Economic Commission for Europe

World Forum for Harmonization of Vehicle Regulations**Working Party on Automated/Autonomous and Connected Vehicles****Twelfth session**

UN Regulations Nos. 13, 13-H, 139, 140 and UN GTR No. 8:**Electromechanical Brakes****Proposal for a supplement to the 11 series of amendments to
UN Regulation No. 13 (Heavy vehicle braking)****Submitted by the expert from the European Association of Automotive
Suppliers***

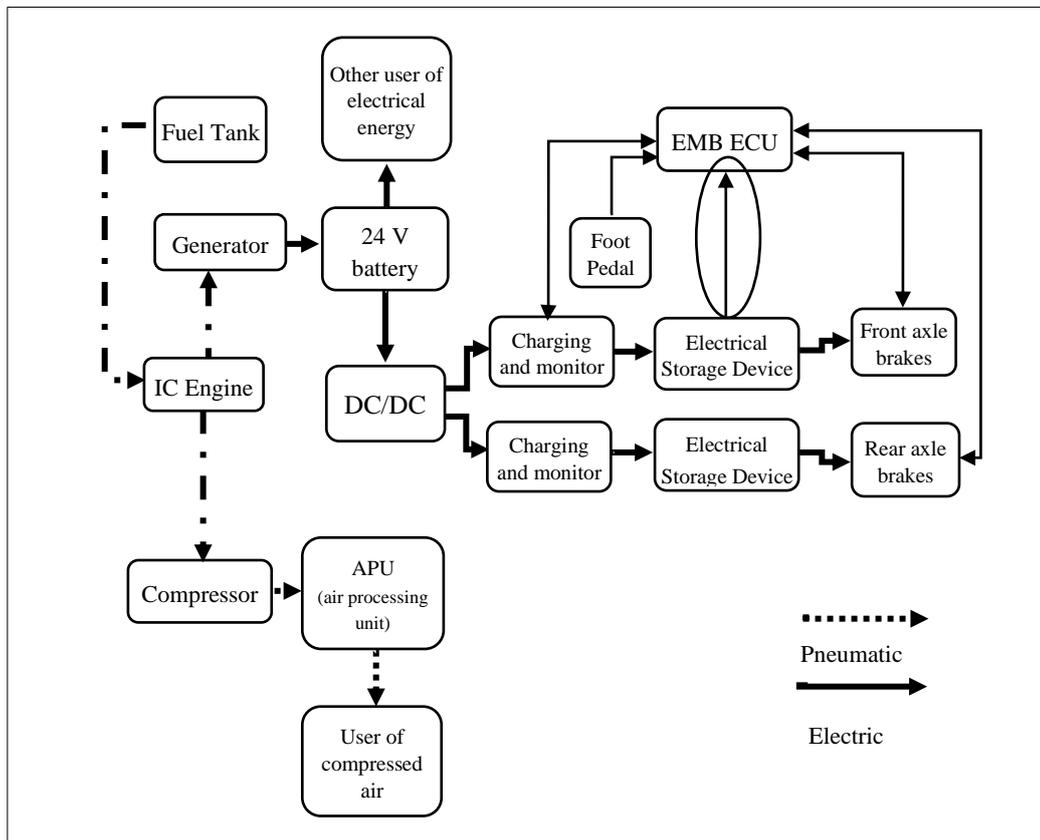
- 5.2.1.35.5. With an electrical energy supply feeding only the electric control transmission and in the event of a failure of that, starting from the nominal value of the energy level, the full control range of the service braking system shall be guaranteed after twenty consecutive full stroke actuations of the service braking control. During the test, the braking control shall be fully applied for 20 seconds and released for 5 seconds on each actuation. It should be understood that during the above test, sufficient energy is available in the energy transmission to ensure full actuation of the service braking system. This requirement shall not be construed as a departure from the requirements of Annex 7, Part D, paragraph 1.

41. Paragraph 5.2.1.35.5. addresses a configuration of an electro-mechanical braking system where an electrical energy storage device (e.g. battery) only supplies energy to the control transmission (but not to the electrical energy transmission as in the case with an EBS which has to comply with paragraph 5.2.1.27.5.); as an exemplary braking system see figure in paragraph 5.2.1.35.5.).

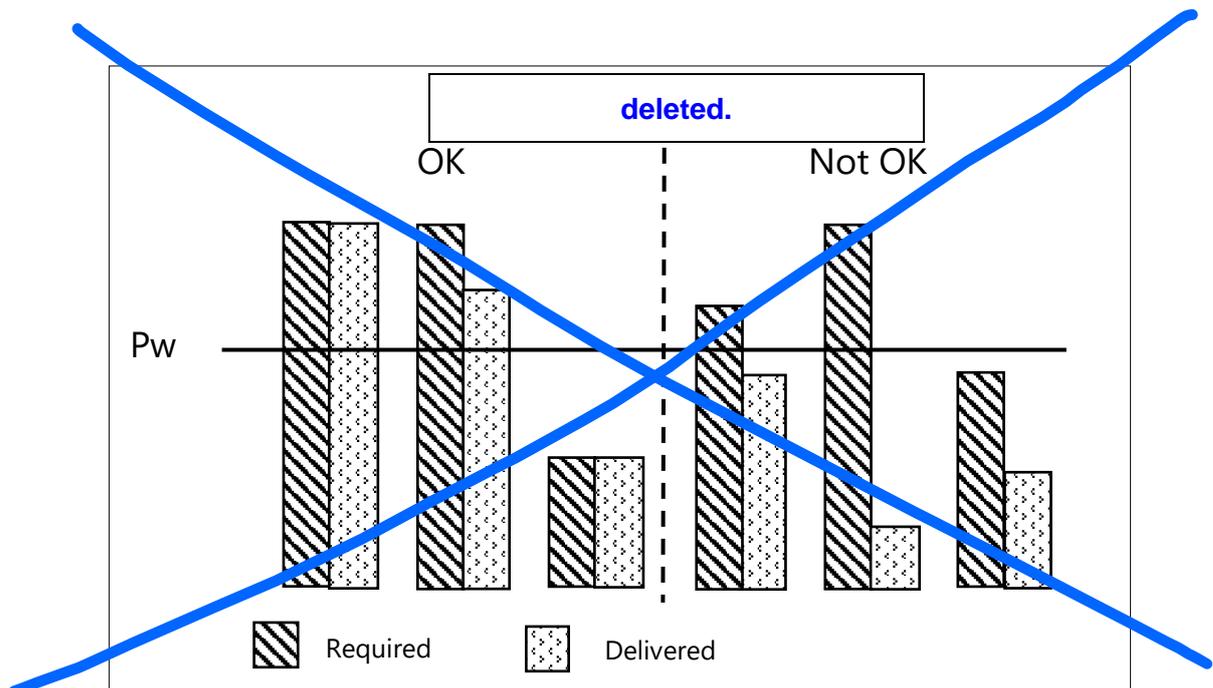
5.2.1.35.6. In the case that the electrical energy storage devices are **also** providing electrical energy for the electrical control **and electrical energy** transmission, the requirements of paragraph 1.2.1. of Part D of Annex 7 shall apply.

42. In contrast to paragraph 5.2.1.35.5., this requirement addresses a configuration of an electro-mechanical braking system where energy storage devices are providing electrical energy for the electrical control and electrical energy transmission; as an exemplary braking system see figure in paragraph 5.2.1.35.6.).
